November 11, 2006
RC-06-0204

Subject: VIRGIL C. SUMMER NUCLEAR STATION (VCSNS)
DOCKET NO. 50/395
OPERATING LICENSE NO. NPF-12
RESPONSE TO NRC QUESTIONS REGARDING
RESPONSE TO GENERIC LETTER 96-06
(TAC NO. M96872)

**South Carolina Electric & Gas Company (SCE&G)
Virgil C. Summer Nuclear Station (VCSNS)
Response to NRC Request for Additional Information (RAI)
Regarding SCE&G Response to Generic Letter (GL) 96-06**

FIGURE 1

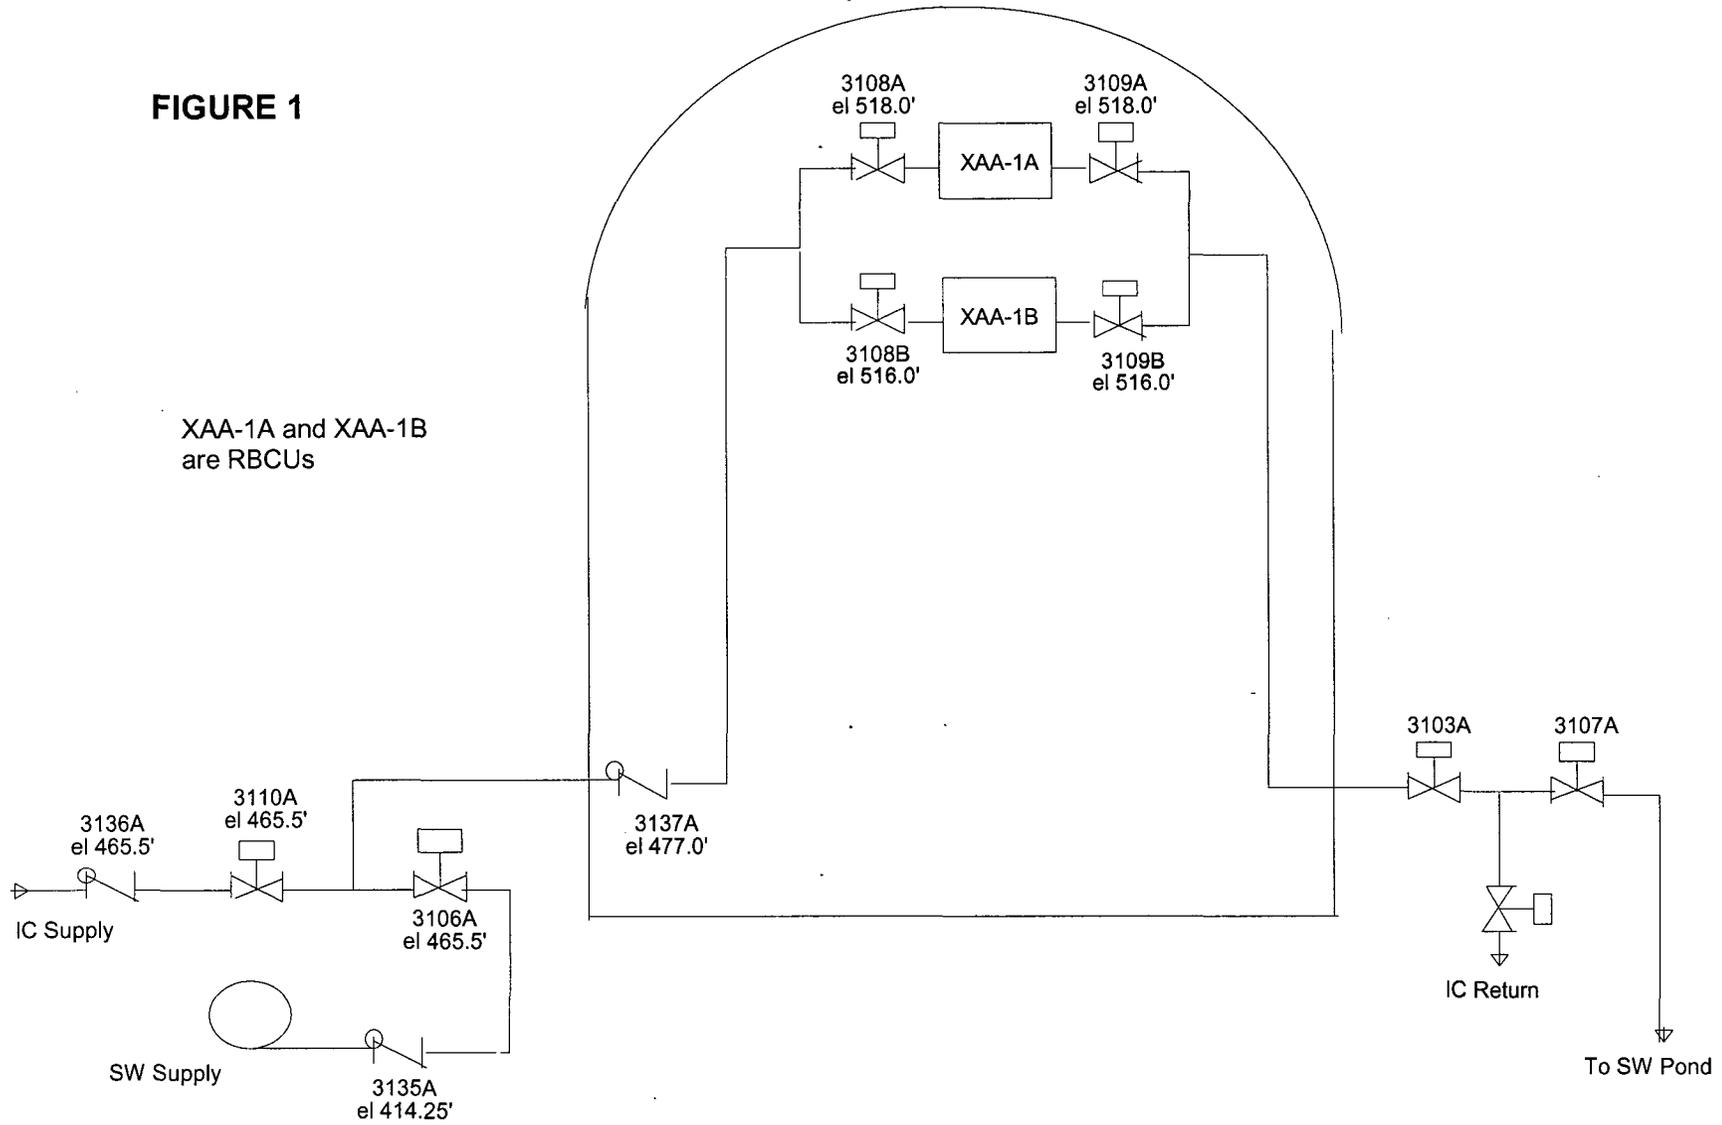
1. The licensee's December 12, 2005, response (pages 5-7 of the Attachment) discusses boundary valve leakage considerations. The worst-case scenario for the GL 96-06 waterhammer event is discussed on pages 15 and 16 of the Attachment. The licensee's analyses of the GL 96-06 waterhammer event scenarios are valid for the specific conditions that have been assumed. If excessive boundary valve leakage occurs, a void could form on the upstream side of the RBCUs that has not been evaluated by the licensee. The licensee's response dismisses this as an incredible occurrence due to the large volume of water that would have to drain from the RBCUs before a void could actually form. However, some containment fan coolers are designed such that the cooling water supply piping enters at the top in order to keep the water from gravity draining should cooling water leak occur. The licensee has not established that the RBCUs at Summer will in fact gravity drain.

Aside from the RBCU design consideration, back-leakage through the SWBP discharge check valves could void the RBCU supply piping upstream of the RBCU supply check valves, resulting in a water column separation of about 63 feet in height (due to a loss of offsite power while cooling is being provided by the SWBPs). Also, because the industrial cooling (IC) cooling system is non-safety related, its integrity cannot be relied upon for loss-of-coolant accident (LOCA) mitigation and the IC system supply side check valves must be relied upon to prevent excessive back-leakage and void formation. However, this is less of a concern than leakage through the SWBP discharge check valves because the IC system is a relatively clean, closed loop system.

On the discharge side of the RBCUs, the RBCU outlet isolation valves must also be relied upon to prevent excessive seat leakage in order to prevent voiding in the piping between the RBCUs and the RBCU discharge isolation valves. Again, the integrity of the IC system cannot be relied upon for LOCA mitigation.

Given these considerations, it is the NRC staff's view that the RBCU boundary isolation valves must be credited for maintaining the water column in the upstream and (to some extent) in the downstream RBCU piping. This view is also consistent with the analysis that was performed by Sargent and Lundy and submitted by SCG&E in a letter dated May 11, 2000. Therefore, in order for the licensee's GL 96-06 waterhammer evaluation to remain valid over time, assurance must be established that the RBCU boundary valves will not leak excessively as the plant ages. This can be accomplished by explicitly crediting the technical specifications (TS) surveillance testing that is referred to on page 17 of the Attachment, and by revising the TS Bases accordingly. Alternatively, other programs for confirming that excessive RBCU boundary valve leakage does not exist can be credited, such as performing periodic valve seat leakage testing. Please discuss measures that will be taken to confirm that the excessive RBCU boundary valve seat leakage does not exist over time, and confirm that the Final Safety Analysis Report and the inservice testing program for Summer will be revised to properly reflect the importance of the closing function of the RBCU boundary

valves for preventing water column separation and voiding in the RBCU cooling water supply and outlet piping.

Refer to Figure 1 (p. 12) for simplified system flow diagram for RBCU cooling. Train A is depicted with Train B similar.

The possibility of voiding due to back flow or back leakage through the valves in the RBCU supply piping during no flow conditions is evaluated in Appendix 1 (p. 3). During RBCU operations, no flow conditions occur during the switch over of RBCU cooling from the IC system to the SW system and vice versa. In addition, voiding could occur in the isolated system branch piping due to valve leakage back to the isolated system. It is concluded in Appendix 1 that column voiding of the size to create a significant waterhammer in the supply piping to the RBCUs during periods of no flow can not occur due to back flow or valve leakage back into the IC system or back into the SW system.

The Final Safety Analysis Report and the system Design Basis Documents will be revised to reflect the closing function of the RBCU boundary valves for preventing water column separation and voiding in the RBCU cooling water supply and outlet piping.

Valve designations and descriptions (Refer to Figure 1, page 12):

XVB03106A(B)	- SW System isolation and containment isolation valve; motor operated butterfly valve
XVC03135A(B)	- SW System check valve
XVB03110A(B)	- IC System isolation and containment isolation valve; motor operated butterfly valve
XVC03136A(B)	- IC System check valve
XVC03137A(B)	- Common SW and IC system redundant check valve in RBCU supply header piping
